Gateway – Furnace air flow and overheating

5SFSG4120DE264319 THRU 5SFSG4128EE278180
2013 and 2014 Gateway 3650BH

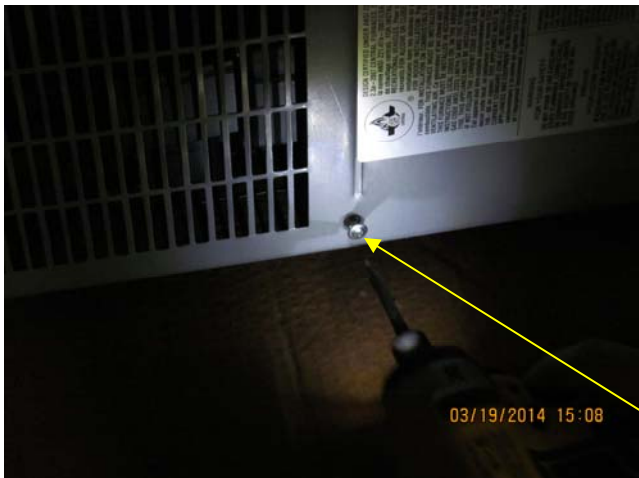
- 1) Remove current air grill and block off panel directly above furnace grill.

Remove the block off panel.

Remove fresh air grill

2) Check furnace and confirm that support leg is in place.

Support leg – should be on bottom, if no leg is present remove screw and attach L-bracket to prevent furnace movement.

- 3) Check furnace and confirm that bottom discharge block off plate is installed. You can feel bottom of the furnace to check the location/installation of block off panel.

Block off panel on
bottom of furnace.

Feel in this location to
confirm panel is in
place.

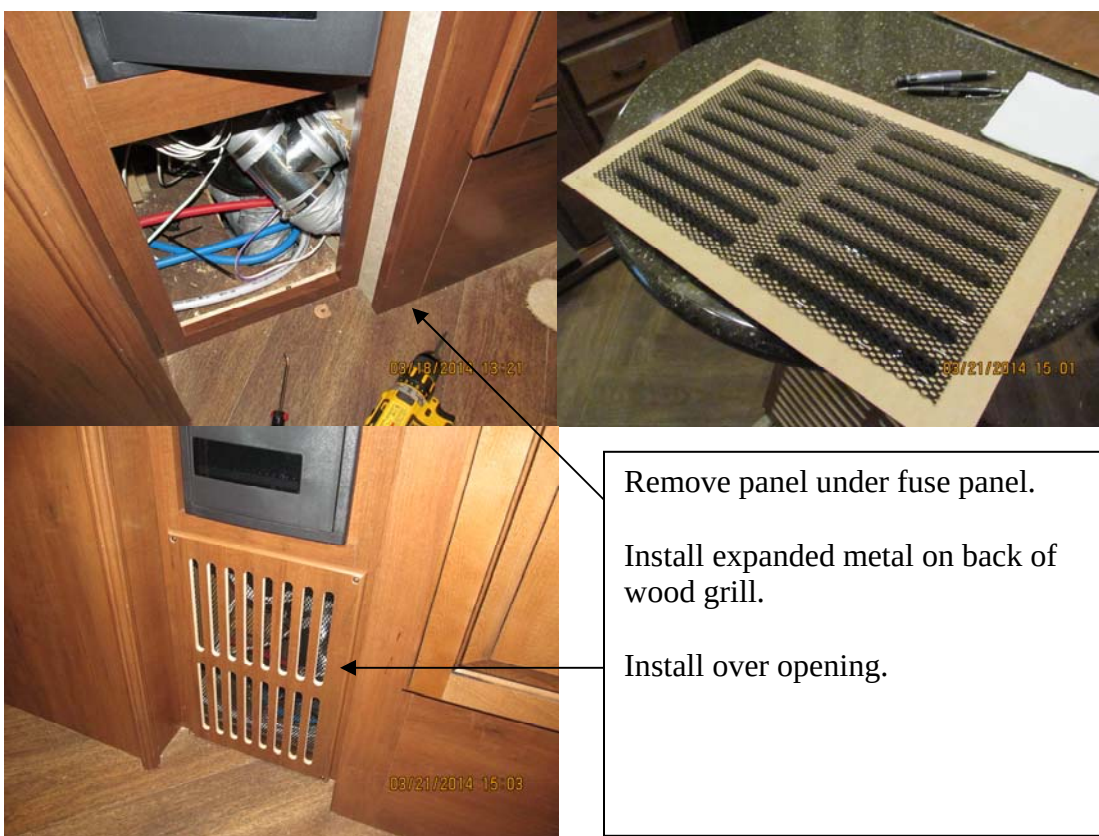
- 5) Add a fifth duct (remove knockout on top of furnace and run flex duct to rear under pantry & lavatory in half bath out to living room toward dinette).

- Add duct to top of furnace.
- Cut opening for register in wall

- Run duct from furnace through wall under the bath lavatory and through wall into living room.
- Install register.
